Notice of request for more information

The Environmental Permitting (England & Wales) Regulations 2016

Application number: EPR/JP3342YM/A001

Dust Emissions Management Plan

- d. Consider the suitability of the monitoring locations presented in 163407/D/006.

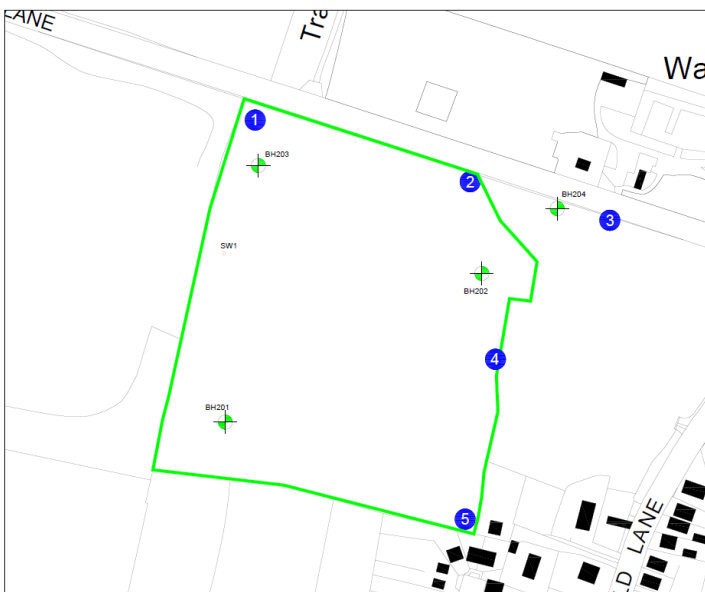
Point 5 is in the south-east corner of the site. It may be difficult to recognise dust leaving the site boundary. To appropriately monitor dust emissions leaving the site boundary towards receptors to the south-east of the site, would the operator consider adding a monitoring location on West End Gardens (outside the boundary of the site), when there is a north-westerly wind? There they can carry out the monitoring as specified in section 5 of the DEMP (e.g. inspection of static objects).
